Project	IEEE 802.16 Broadband Wireless Access Working Group < http://ieee802.org/16 >
Title	Proposed text and ASN.1 code for QoS Management
Date Submitted	2007-05-08
Source(s)	Joey Chou Intel Corporation [mailto:joey.chou@intel.com]
Re:	
Abstract	This contribution proposes the text and ASN.1 code in wmanIf2mMib to support QoS management.
Purpose	Adoption
Notice	This document has been prepared to assist IEEE 802.16. It is offered as a basis for discussion and is not binding on the contributing individual(s) or organization(s). The material in this document is subject to change in form and content after further study. The contributor(s) reserve(s) the right to add, amend or withdraw material contained herein.
Release	The contributor grants a free, irrevocable license to the IEEE to incorporate material contained in this contribution, and any modifications thereof, in the creation of an IEEE Standards publication; to copyright in the IEEE's name any IEEE Standards publication even though it may include portions of this contribution; and at the IEEE's sole discretion to permit others to reproduce in whole or in part the resulting IEEE Standards publication. The contributor also acknowl

Figure 19—wmanIf2mCmnCm structure

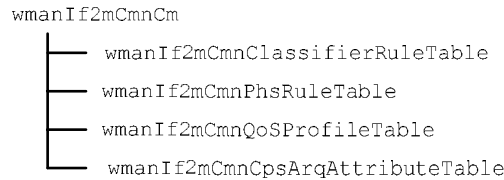
[Add a new subclause as the following:]

Figure 19 shows the structure of wmanIf2mCmnCm subtree that contains common managed objects related to Configuration Management.
